SYDNEY CENTRAL CITY PLANNING PANEL

SUBJECT: 62 Ferndell Street, SOUTH GRANVILLE

FILE No: DA-384/2018

| Proposed Development | Construction of four industrial buildings with 24 hour operations 7 days a week, including signage, parking and associated landscaping and stormwater works |

Figure 5: Biodiversity area as per PLEP2011 maps.

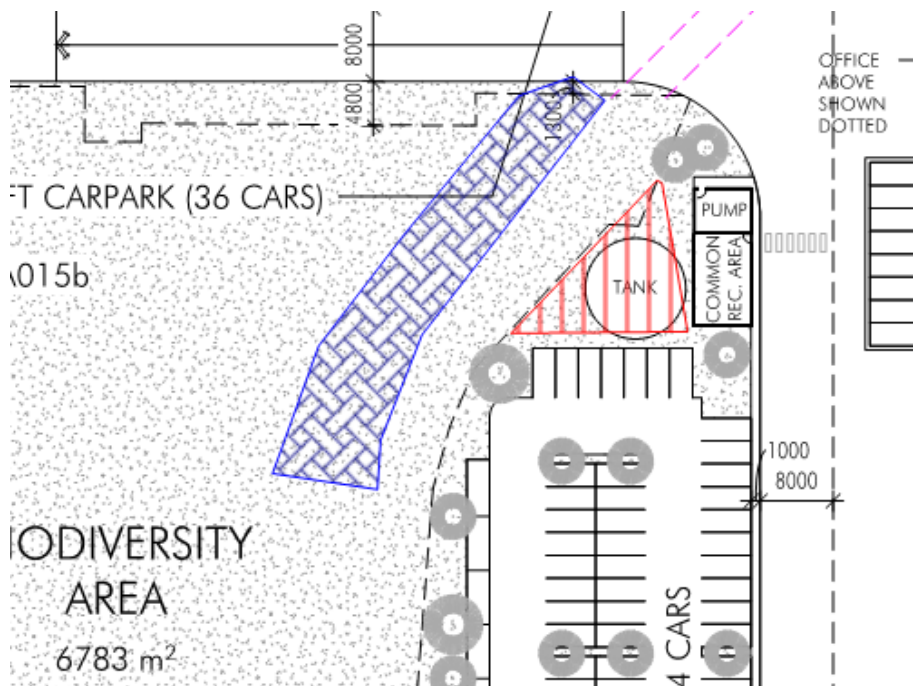
Given the proposed works to the eastern edge of the biodiversity area, a Biodiversity Consideration letter/report prepared by Lesryk Environmental Pty Ltd dated 4 December 2018 shows the extent of the proposed works in the context of the Biodiversity area and provides an analysis of the impacts and recommendations.

The works are required so as to ensure that all stormwater from the site is captured and does not result in increased overland flow to adjoining properties, including to the Environmental Conservation area within the adjoining Reserve. The letter/report prepared by Lesryk Environmental Pty Ltd identified that the works will require removal of approximately 1,300sqm of degraded woodland which includes Cooks River/Castlereagh Ironbark Forest (listed as critically endangered under the *Commonwealth Environment Protection and Biodiversity Conservation Act 1999* (EPBC Act) and endangered under the *NSW Biodiversity Conservation Act 2016* (BC Act), and River-flat Eucalyptus Forest (listed as endangered under the BC Act). After undertaking assessment in accordance with the aforementioned Acts, it was concluded that the proposed excavation works would not have a significant impact on either community. It was also found that no flora or fauna species listed under either of the Acts were recorded within, or in close proximity to, the subject site, nor would any be reliant upon the subject site for any of the necessary lifecycle requirements. It was further concluded that the proposed works would not remove or have a significant impact on any ecological communities, plants or animals of national, state or regional significance.
